UNITED STATES
NUCLEAR REGULATORY COMMISSION
WASHINGTON, D. C. 20555

FACILITY: Watts Bar Nuclear Plant, Units 1 and 2

SUBJECT: MEETING SUMMARY FOR THE FEBRUARY 7-8, 1989 MEETING REGARDING
WATTS BAR CORRECTIVE ACTION PROGRAMS

COMPARISON OF SET B AND SET C SPECTRA

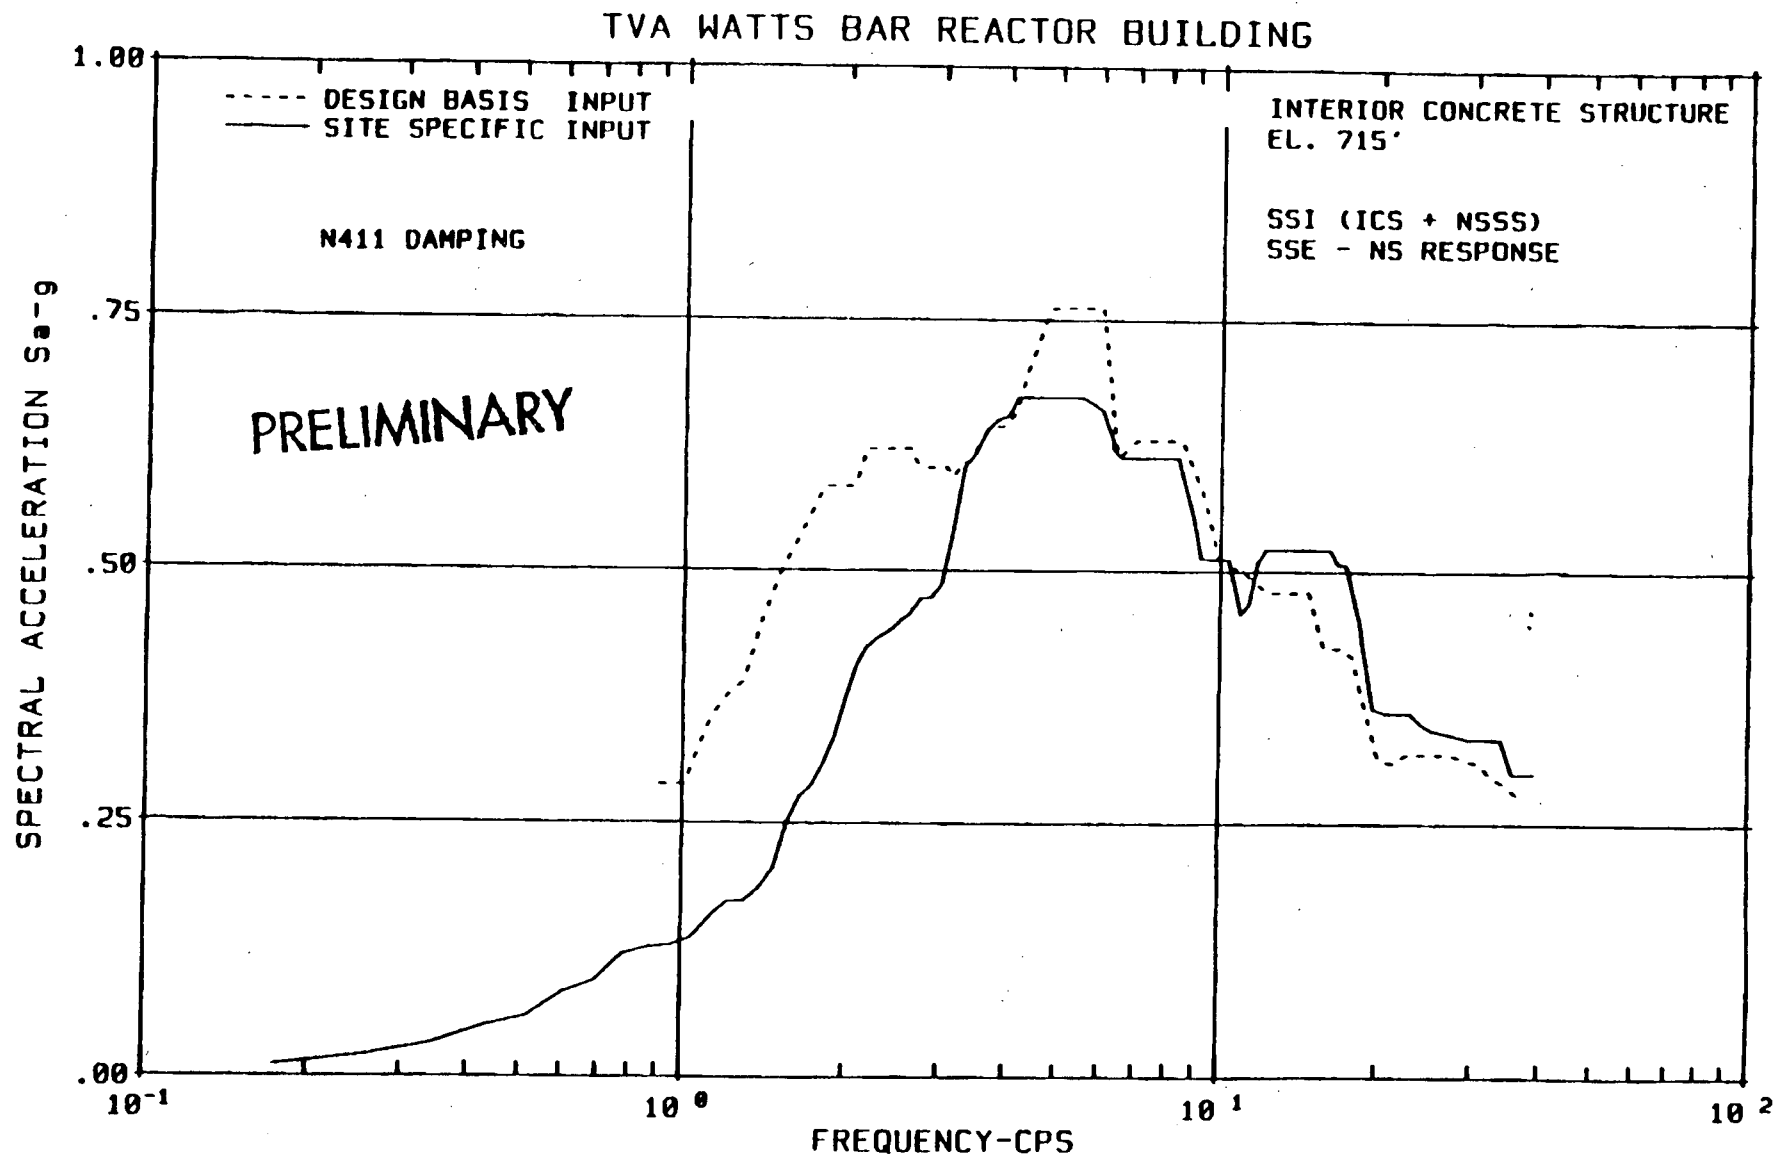
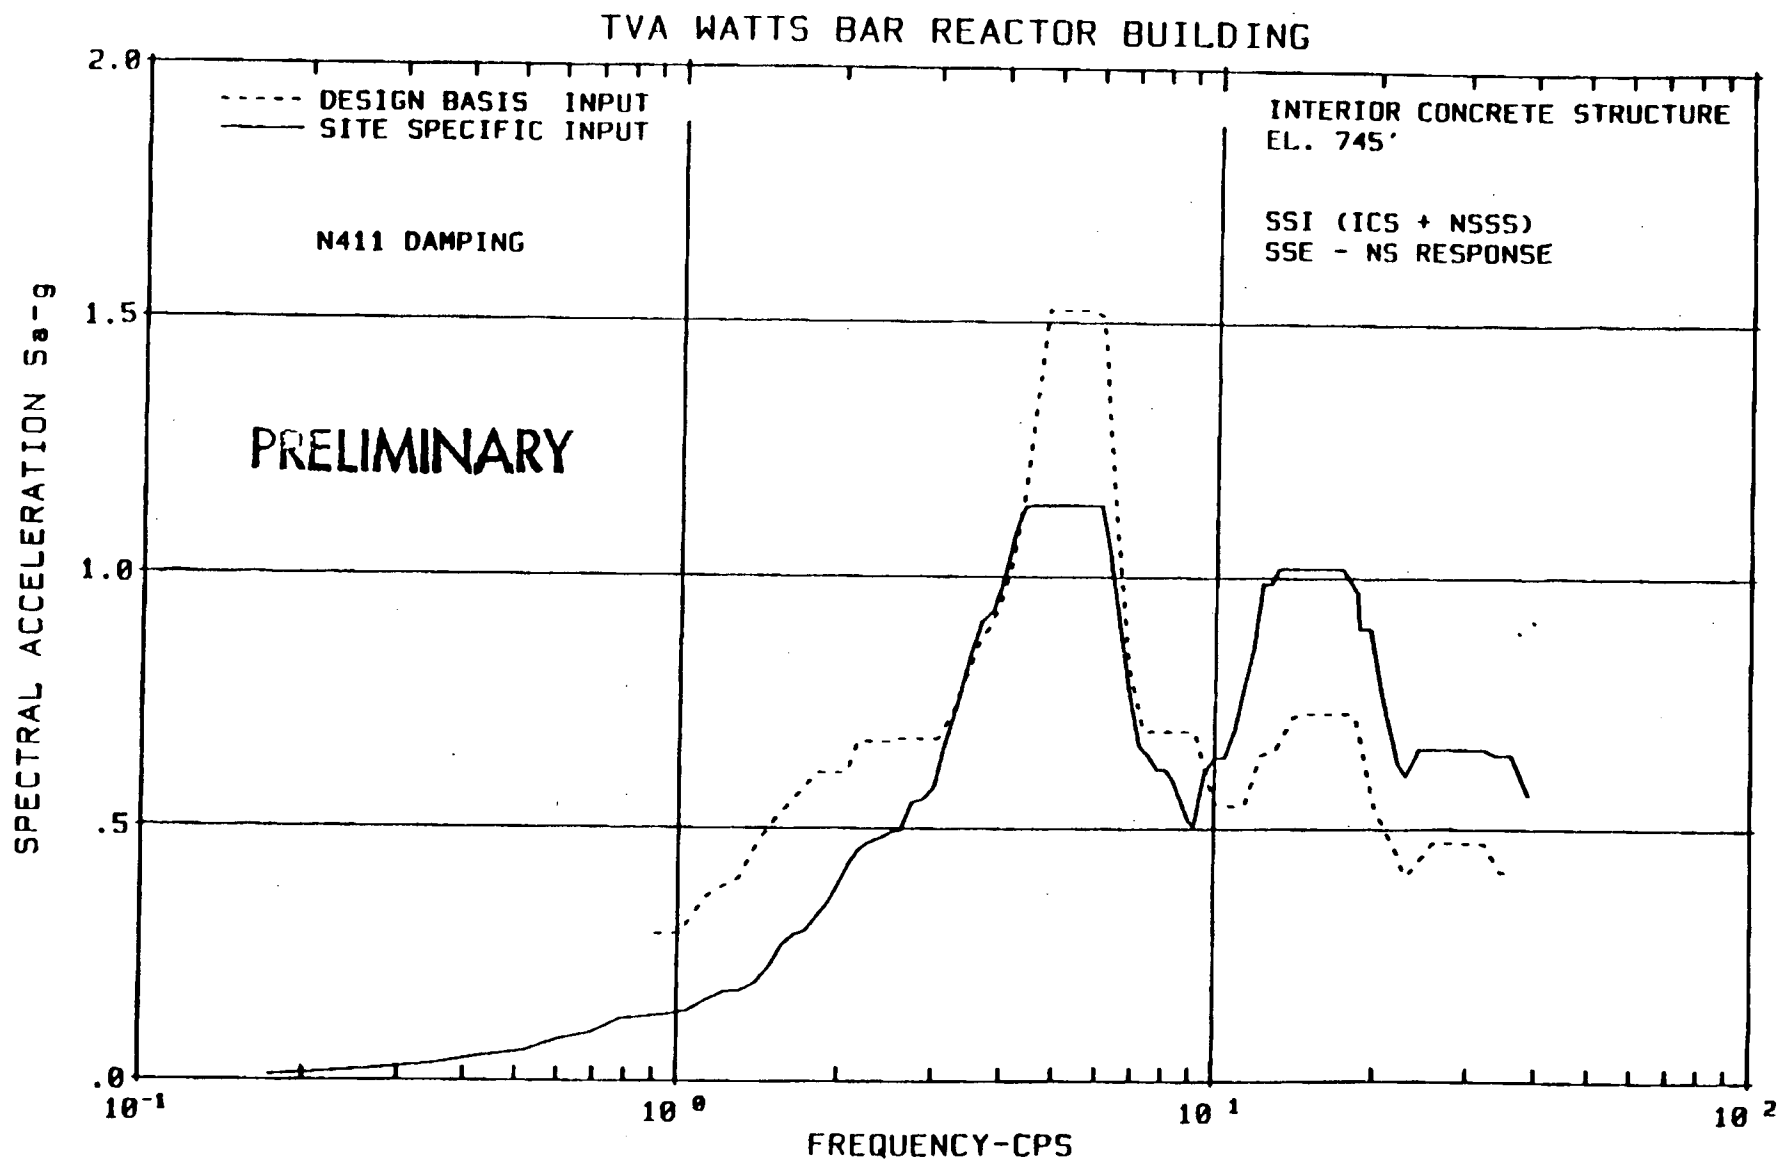
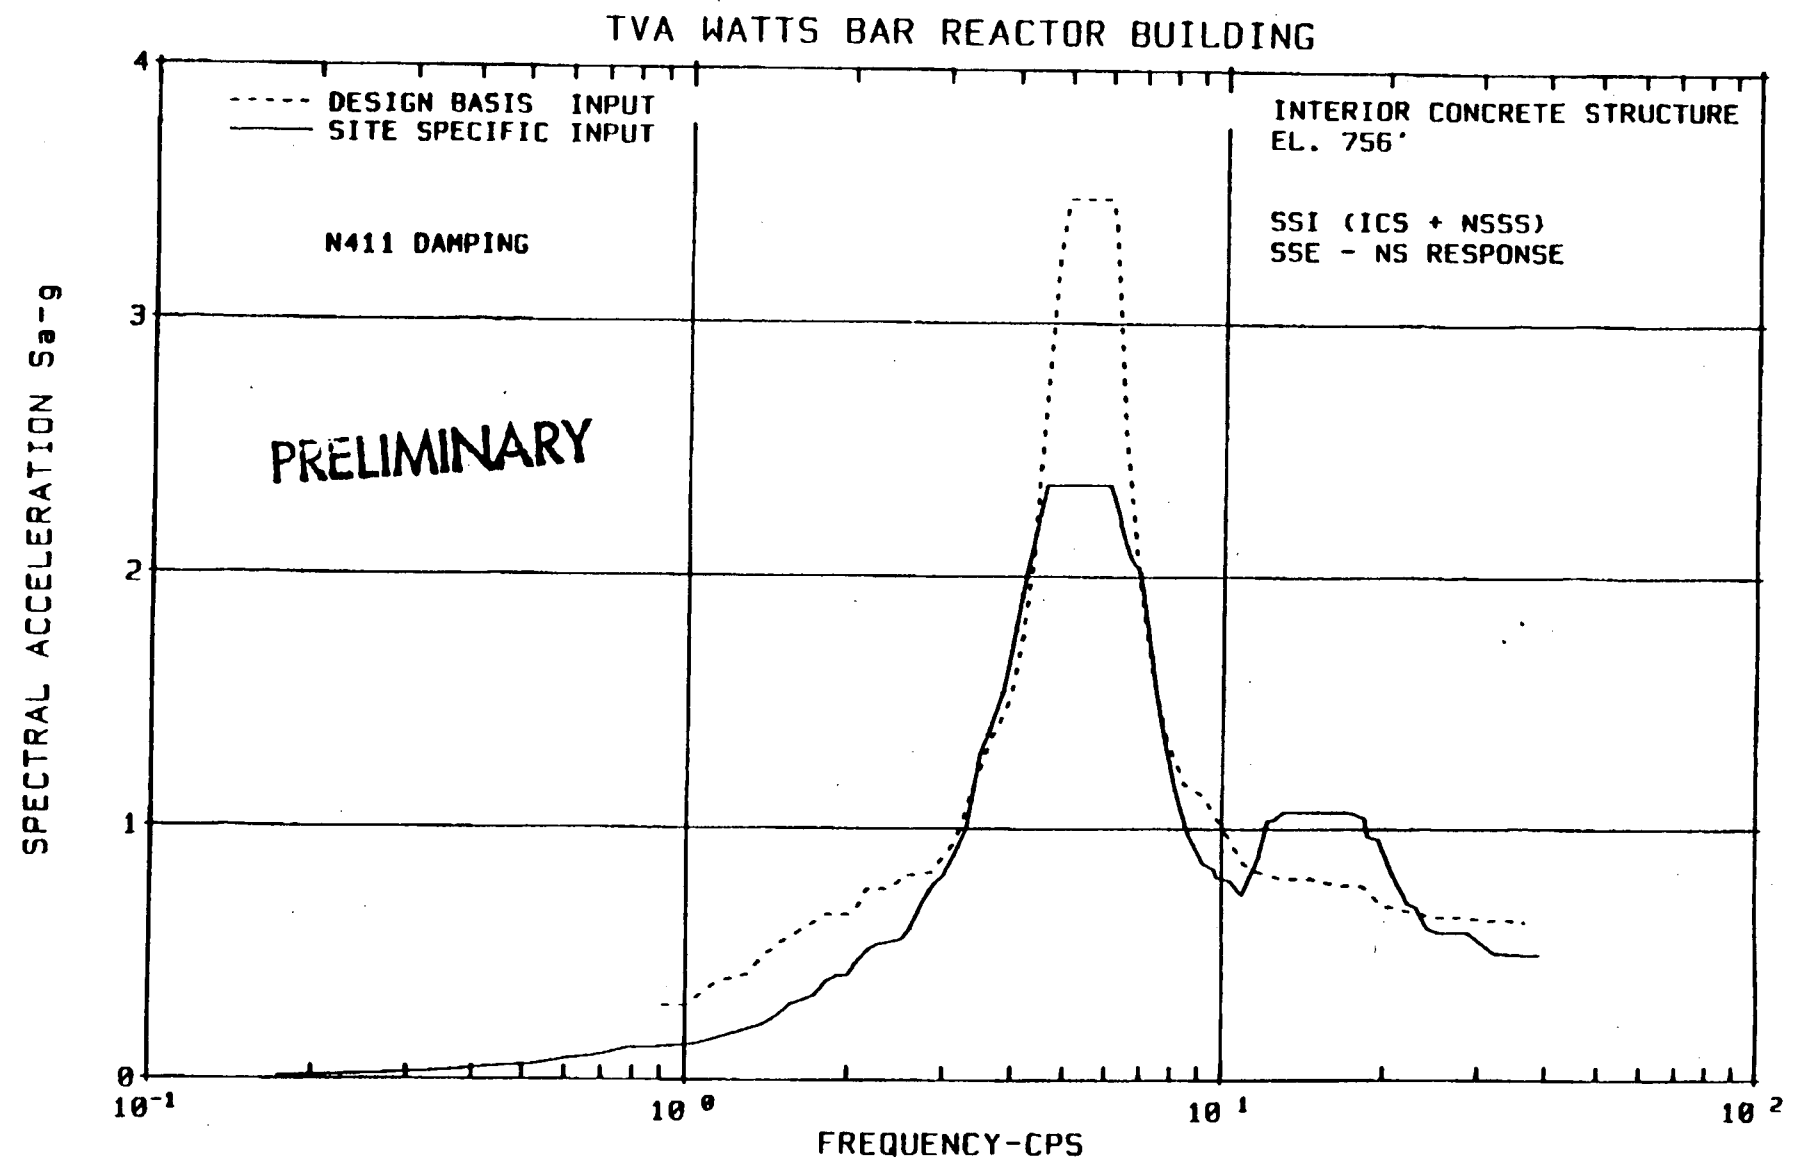
3. TVA and NRC are to assess the use of envelope of the ARS obtained from "Set B" and "Set C" analysis for use with ASME Code Case N-411.
4. Table 2 of the seismic CAP needs to be clarified in a number of areas to explicitly convey TVA's intent (e.g., explain what is meant by "same.").

1. TVA is to submit a revision to the seismic CAP to reflect the "Set B" and "Set C" criteria and how TVA will use each criteria set.
2. TVA will provide a copy of the seismic design criteria when revised to reflect "Set B" and "Set C" criteria.
